# CITY OF ALBUQUERQUE

PLANNING DEPARTMENT – Development Review Services

RE: **Signal Points lots 19 & 20**  
**Block 4, Tract 3, Unit 3, N. Albuquerque Acres**  
**Grading and Drainage Plan**  
**Engineer's Stamp Date: 3/2/15 (C20D070)**

Grading & Drainage Plan

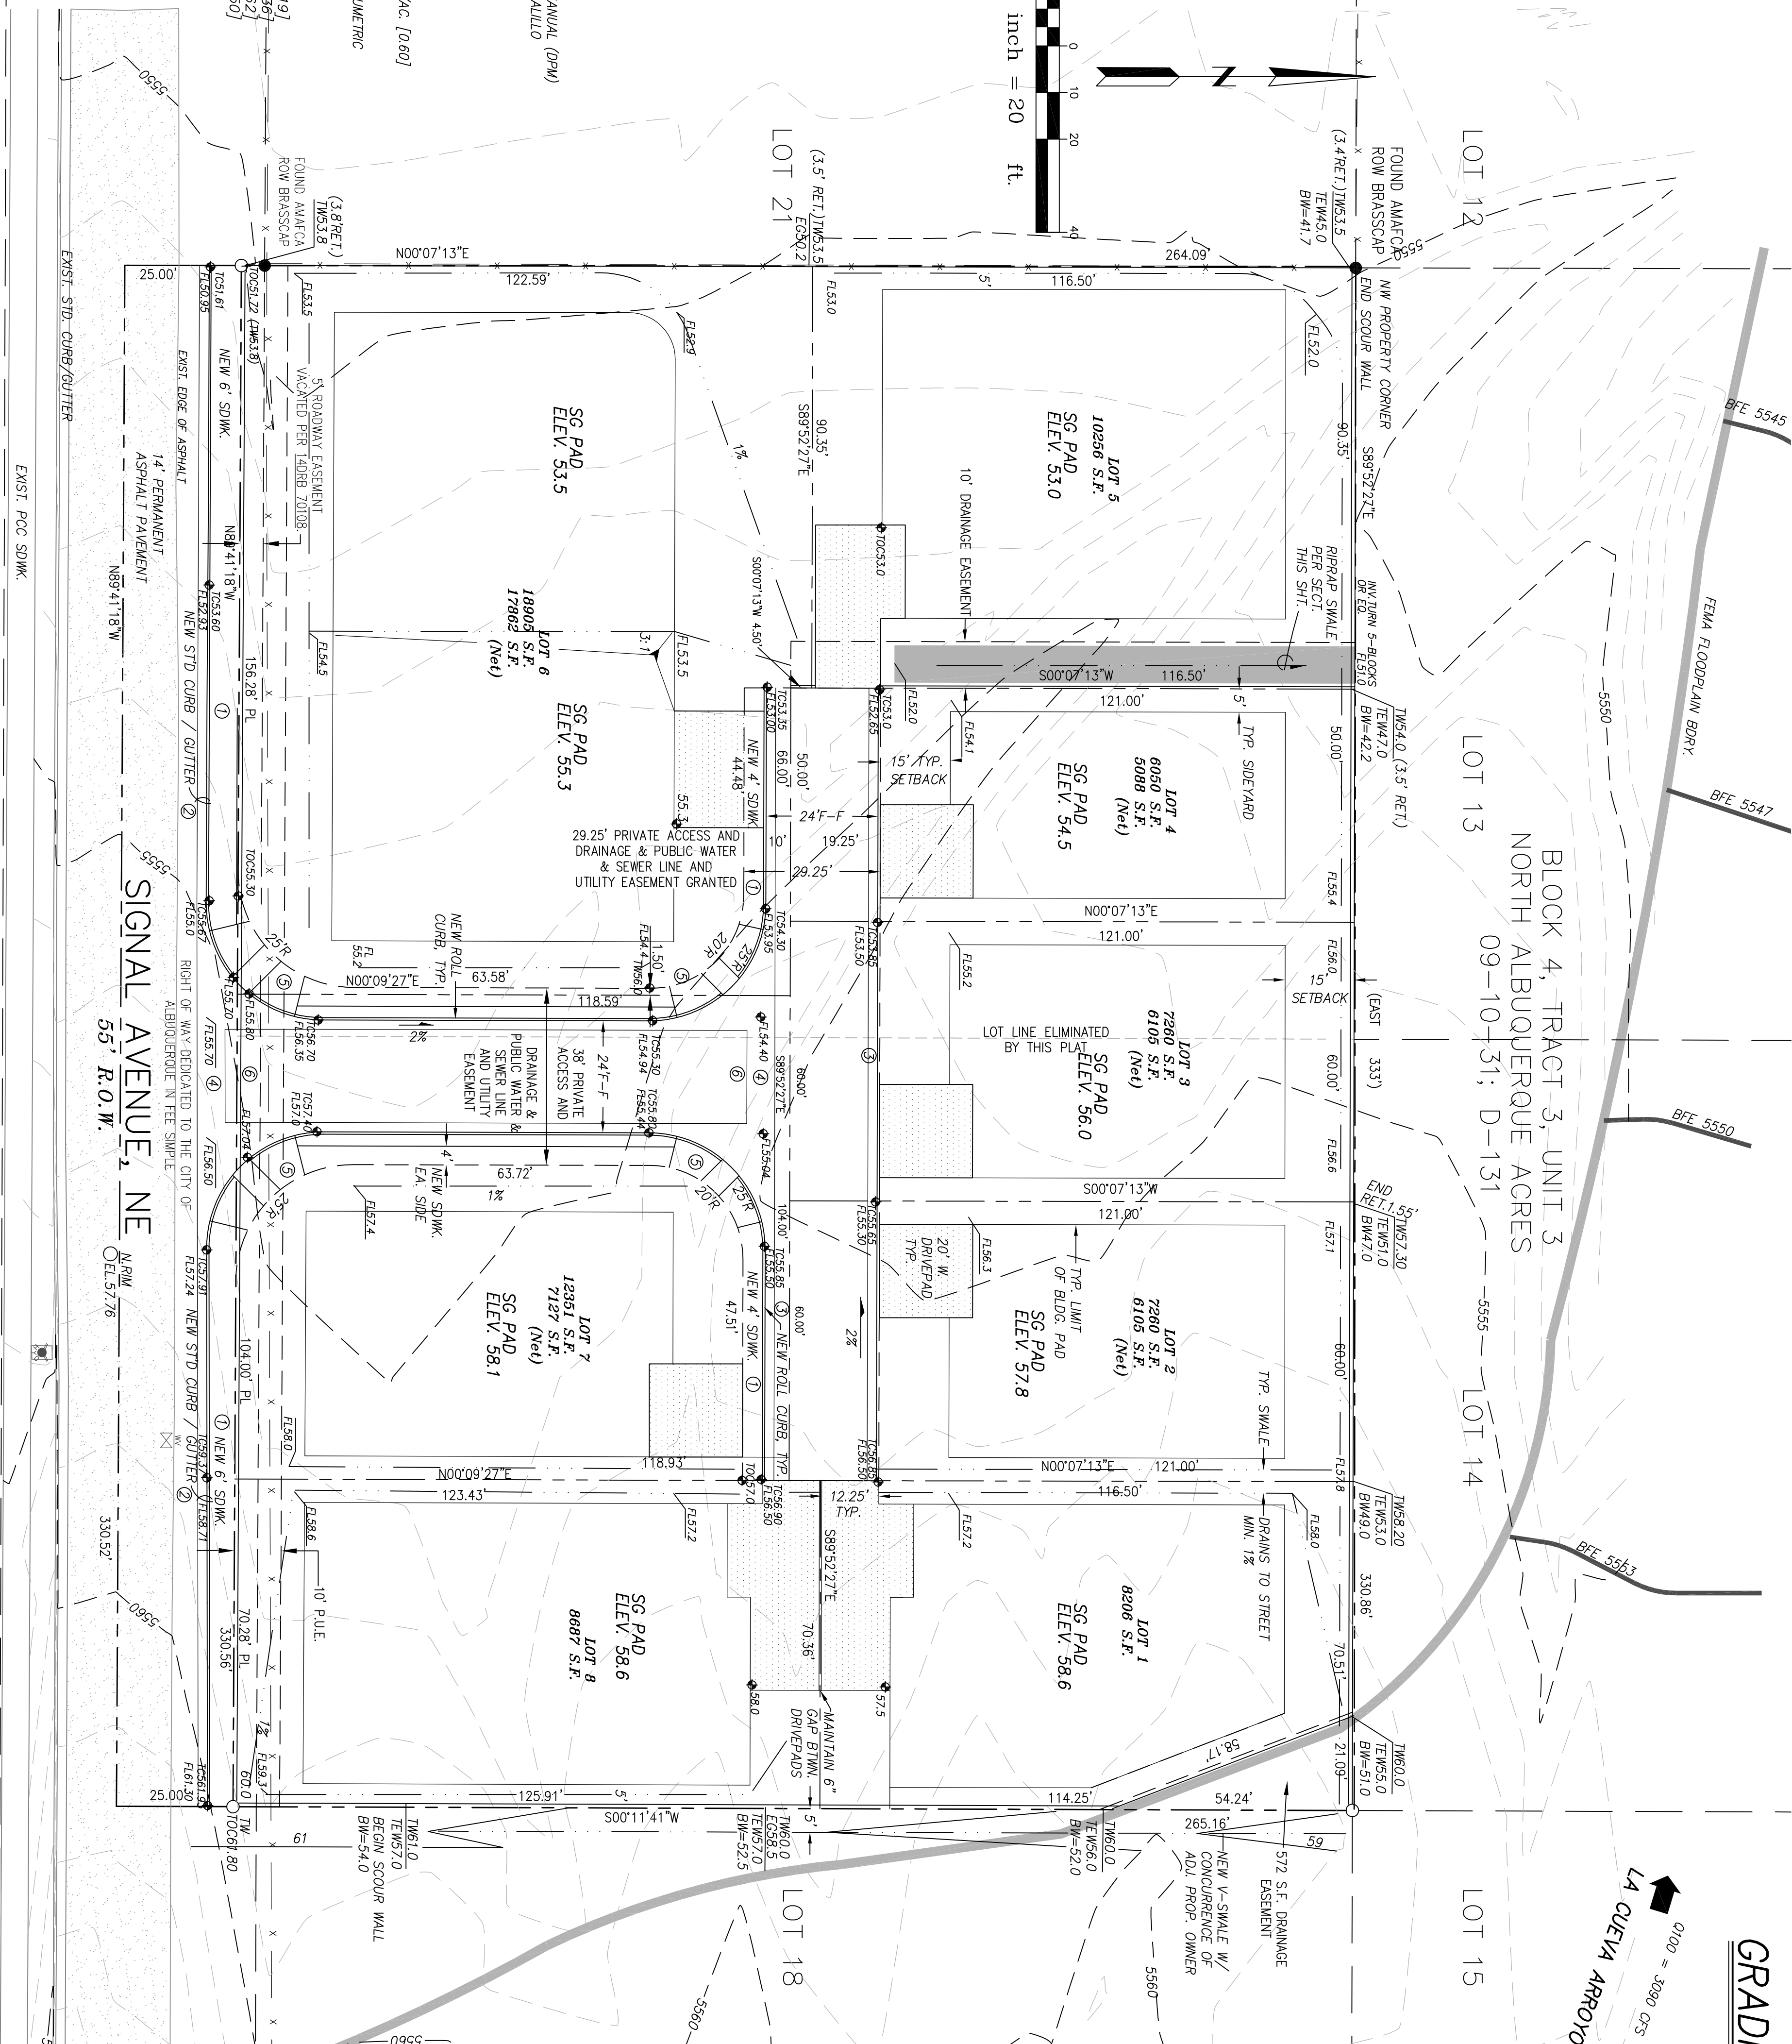
- Address first flush requirements
- A branch of the North La Cueva arroyo breaches the Flood Plain limits and passes thru this site as shown by the aerials and site visits. There have been numerous conversations on acceptable mechanisms to deal with this scenario. These means were delineated in a letter dated 3-21-14 and are in the drainage file. Upon further conjecture, item 2a. will require a LOMR.
- Quantify flows from the La Cueva Arroyo breach and provide HES-RAS calculations.
- Provide adequate protection from the arroyo.

The pond shown will be fine for the management of the first flush.  
If you have any questions, you can contact me at 924-3695.
